Arlington High School Building Committee

Meeting Date: Tuesday, April 6, 2021 - 6:00 pm
Location: Conducted via Remote Participation

Change Order (CO)

Items included in this Change Order:	Cost:
CR 072A Expand Terrazzo flooring throughout Cafeteria (PR-002)	\$ 219,338.20

12/18/2020:
Proposal Request
PR-002

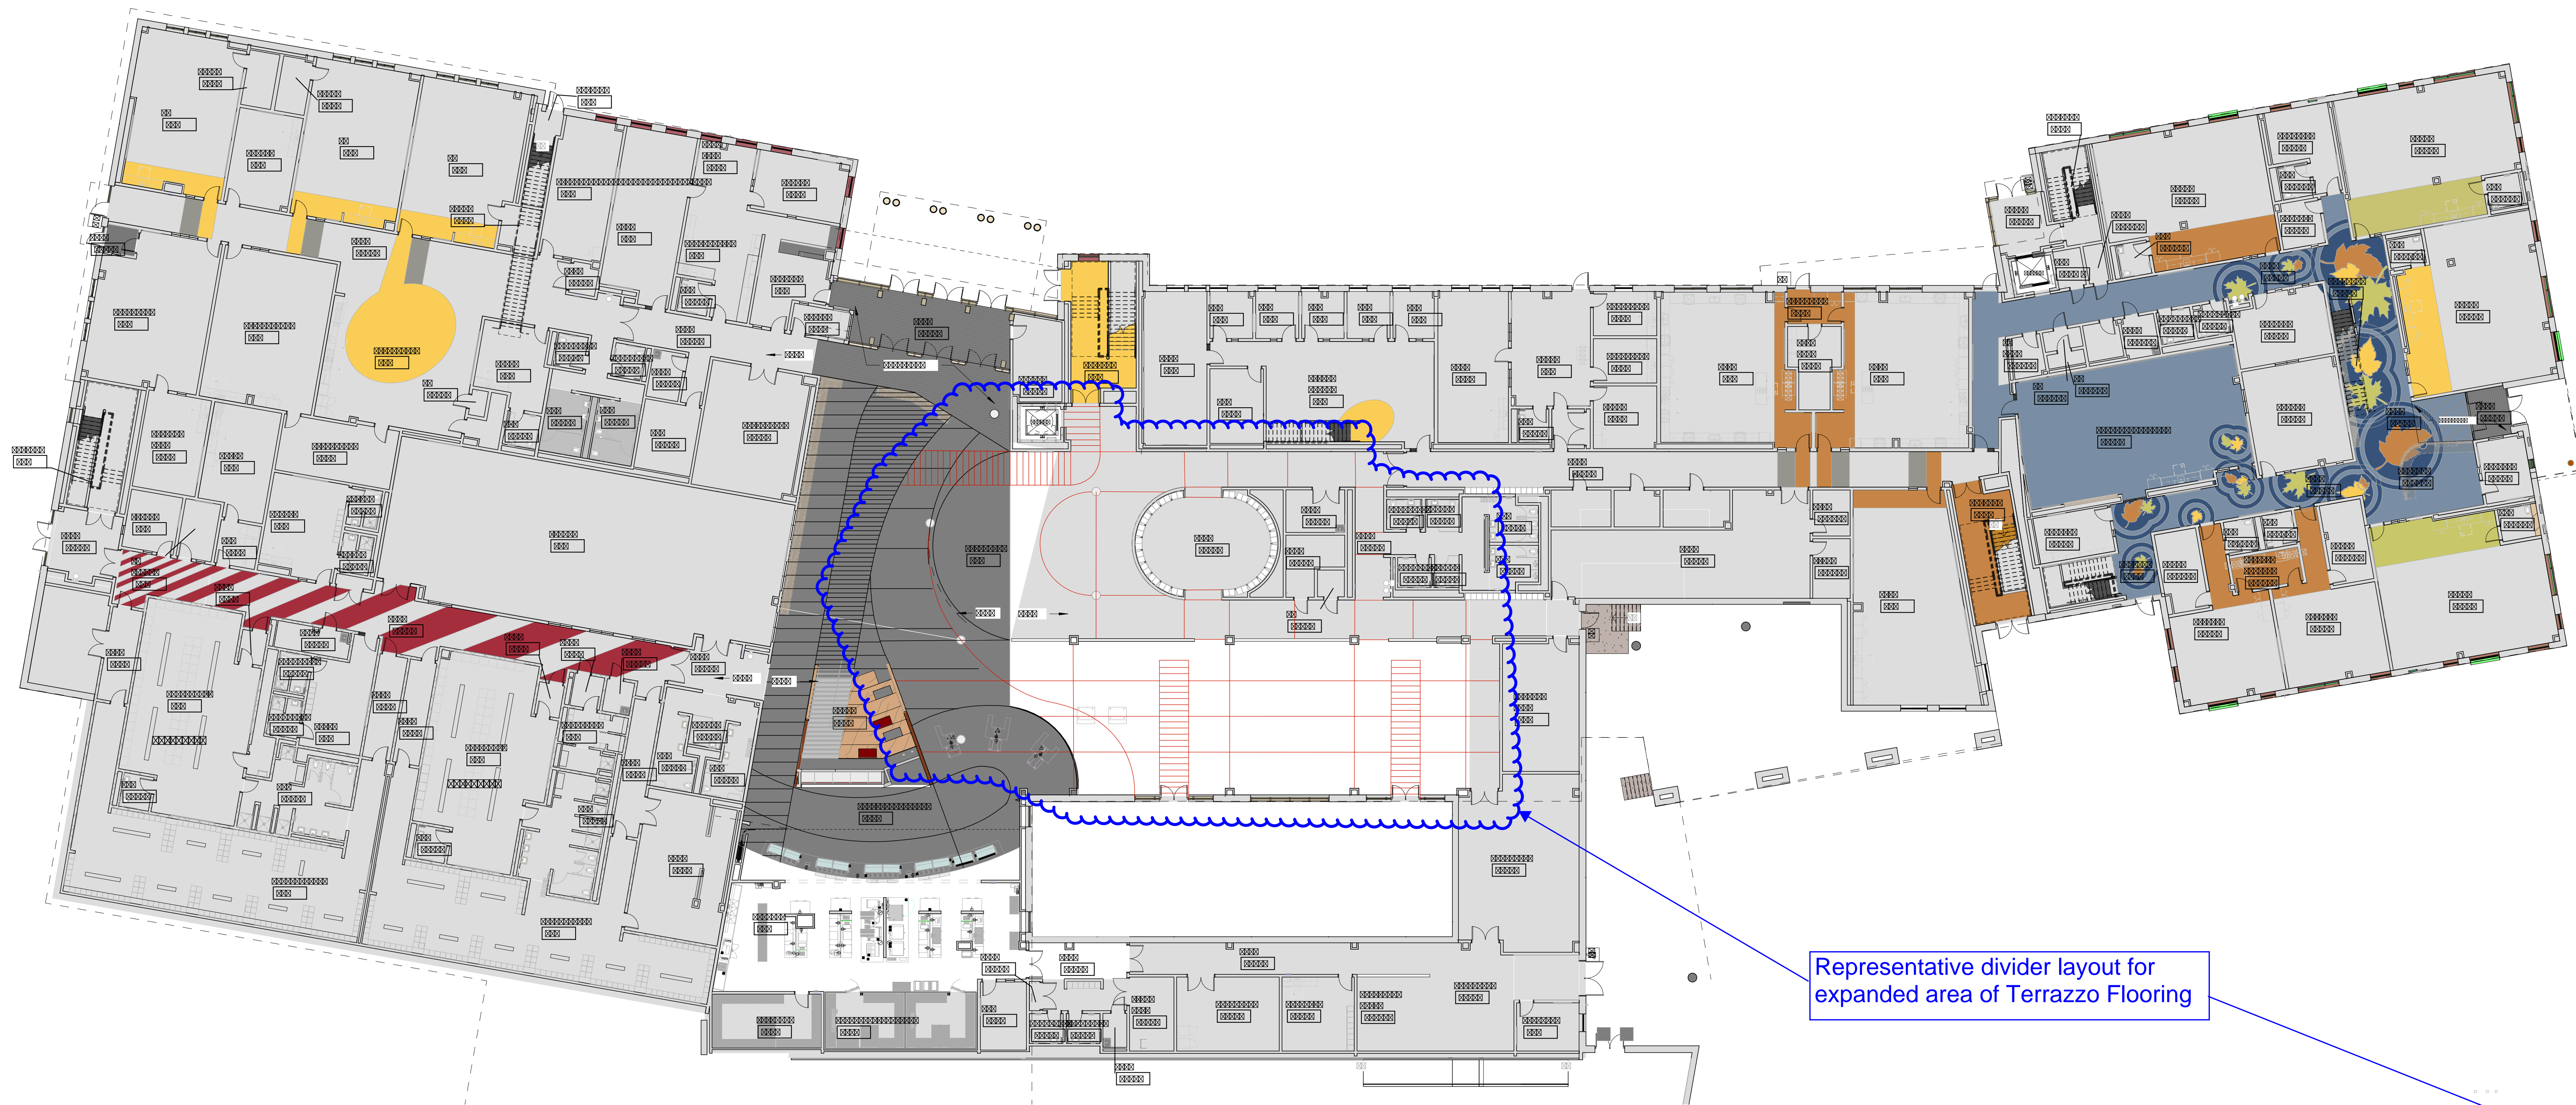
Change Polished-Stained Concrete floor (AFC-1) areas within the 1st floor Cafeteria and at adjacent Corridors C1-01, C1-02 and at portion of entry alcove corridor to Toilets T1-01/ T1-06 to be Terrazzo Flooring.

See attached plan A2.0b highlighting (blue) the areas to be changed.

See attached plan A2.9.0 indication of terrazzo divider strip layout pattern (representative-for pricing).

Note that limits of 3/8" slab depression will revise/be relocated to include this expanded area of Terrazzo.

Change Corridor C1-06 flooring from Polished-Stained Concrete floor (AFC-1) **to be RF (Resilient Tile Flooring)**. Provide separate pricing for both the specified MCT tile and for PR-001 "Modular" Tile.
